APA Frame Compliance Office Response to Analysis¶

LBNF/DUNE FDR: APA

LBNF / DUNE Compliance Office System Structural Validation document – DESIGN

DUNE APA frame

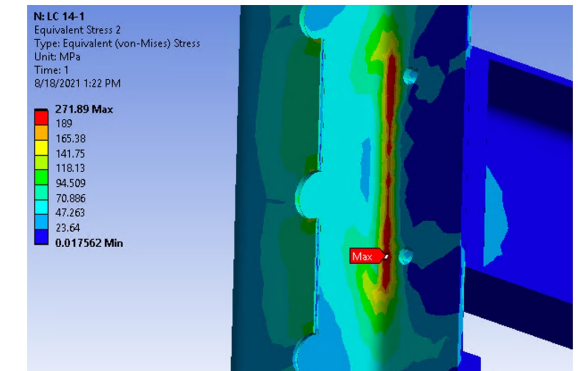
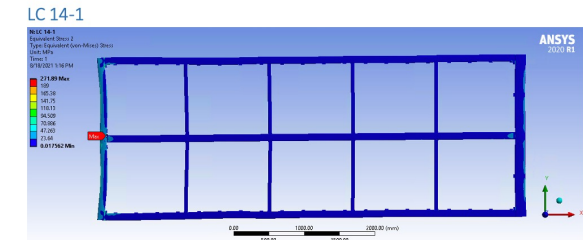
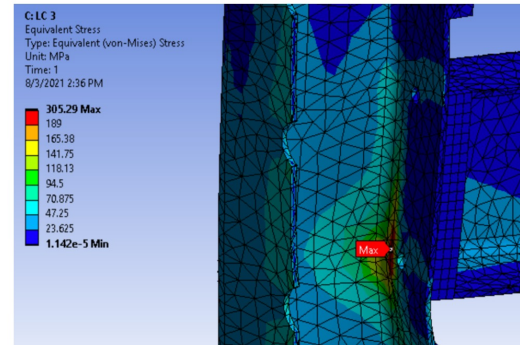
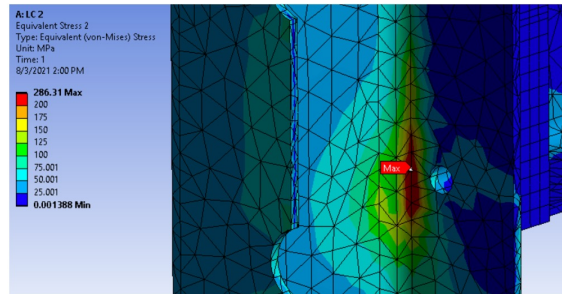
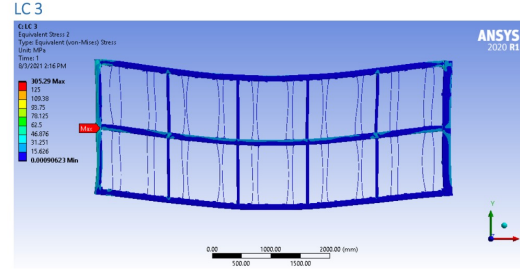
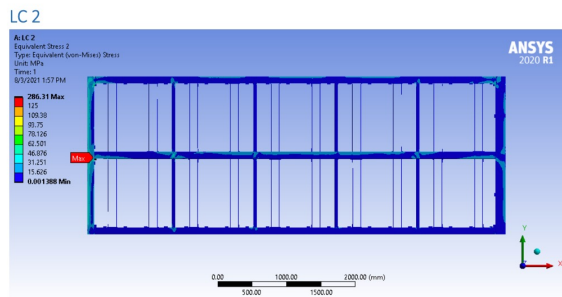
High stresses concentrations are identified in a specific area of the APA frame for several static load cases. Additional investigations are required and waiting dynamic loads results.

APA supported on the winding machine

Thermal load case – 50 % extra wire pre-load (cool down)

Envelopes should be checked in all configurations (transport, installation, operation)
